**Safety Defect and Noncompliance Report Guide for Vehicles**  
**PART 573 Defect and Noncompliance Report<sup>1</sup>**

**RE: NHTSA Recall No. 03V-617**

RSB03-160-001

## RECALL SERVICE BULLETIN

FIG. 4-1

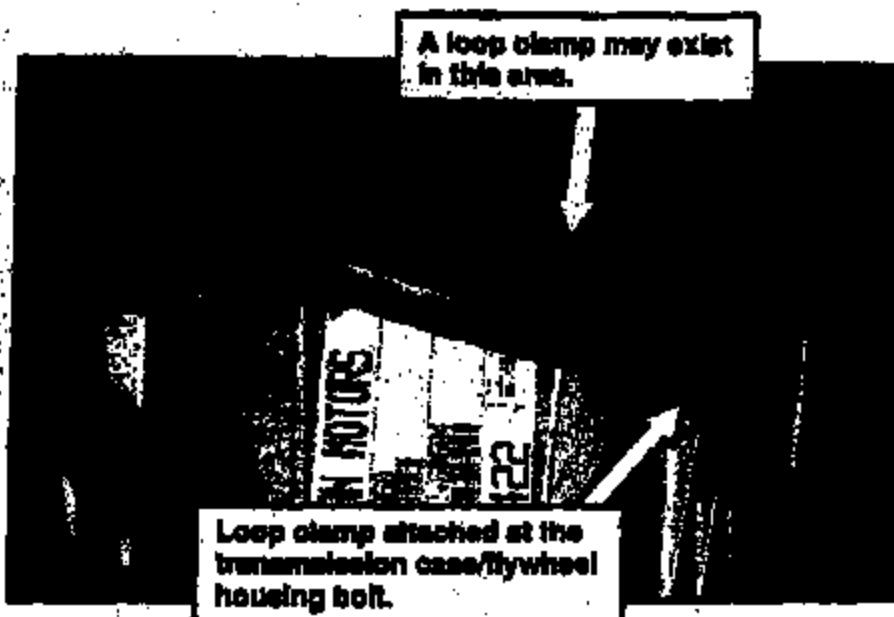
Route hose from the fan motor, over the flywheel housing (rather than under), and connect to the 45° fitting at the pump.

- 11a. Install a loop clamp to the transmission case/flywheel housing bolt closest to the dipstick tube as viewed from the top of the transmission. Refer to FIG. 4-1. If a clamp exists at a different transmission case/flywheel housing bolt, relocate it to accommodate the routing as shown. Torque bolt to 41 +/- 3 lb. ft.

FIG. 6-1

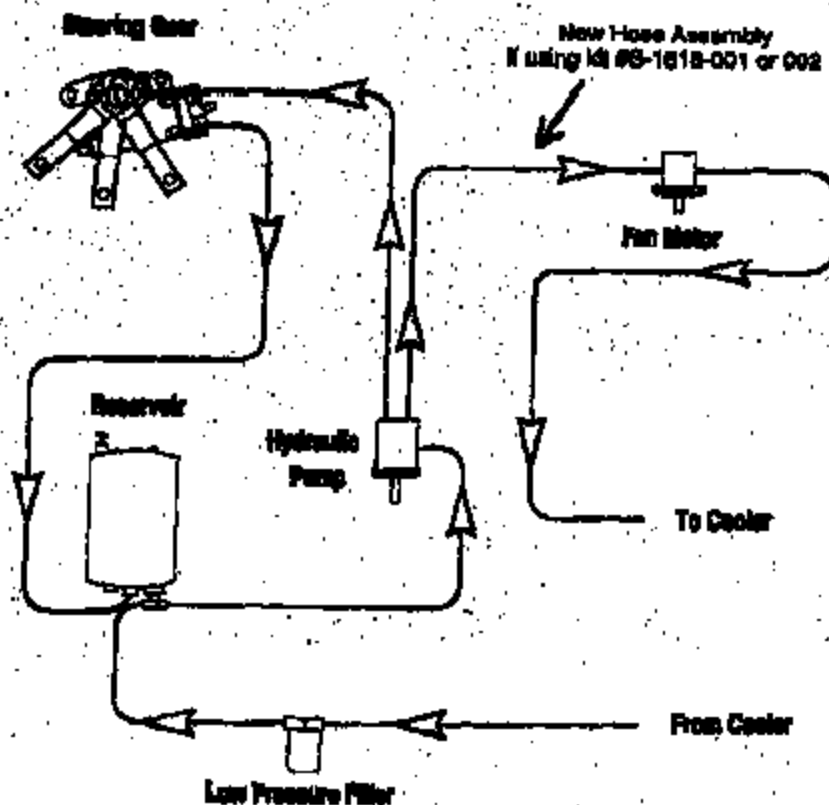
22. Refill the hydraulic reservoir until it is close to full with the appropriate fluid as stated on the reservoir information label. DO NOT steer.
